**UPGRADE OF KLAARSTROOM OXIDATION POND
WASTEWATER TREATMENT SYSTEM**

COMMENTS AND RESPONSE REPORT

DATE: AUGUST 2019

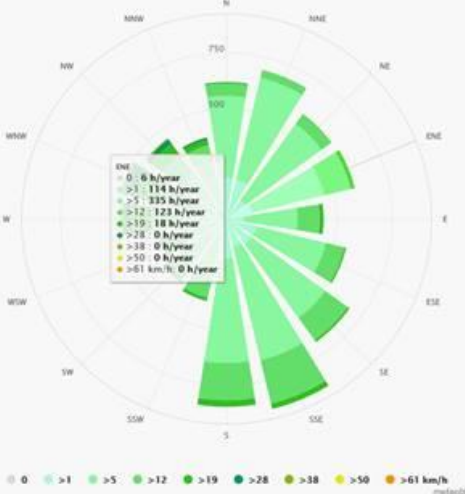
<p>sludge prior to transportation for off-site use/disposal been explored (as per sludge classification and relevant disposal options)? Drying beds should be considered as wet sludge will pose a much higher risk of groundwater contamination, should the wet sludge be buried or stored on an unlined permeable surface.</p> <p>4. Page 19 states that construction is expected to take four months and goes on to say that construction will commence in July 2019 and end August 2019. This is two months as mentioned, please clarify.</p> <p>5. The irrigation of the sports field will occur closer to residential areas than the current irrigation area. What are the predominant wind directions as the sports field is close to residential dwellings. What arrangements are being made for the winter periods when sports fields are saturated and the demand for watering is limited?</p>	<p>4. Thank you for pointing out this inconsistency. Construction is expected to take a period of 4 – 6 months. Construction to start as soon as all legal authorisations have been obtained.</p> <p>5. The prevailing wind directions are North-North East and South-South East. This means that the winds will blow over the village towards the sportsfields. It also means that the current situation is very similar, as the irrigated area is directly north of the village. See windrose for Klaarstroom below based on 30 years of hourly data.</p>	<p>Gert Meiring (BVI Engineers)</p>

<p>Gert Meiring] The annual evaporation rate at Klaarstroom is in excess of 2200mm per annum. This means that the average volume that will be evaporated from the ponds' surface is in the order of 22m³ per day average. This varies from about 8m³/day in winter up to 26m³/day in summer months. The result of this is that the water available for irrigation will only be about 4mm per day on average. The risk that there will be large volumes of poorly treated effluent irrigated onto sportsfields is therefore very small. Even in winter, it will be basically impossible to "water log" the sportsfield with a precipitation of 4mm per day.</p>	<p>Gert Meiring (BVI Engineers)</p>
--	--	--	--	--	---	---
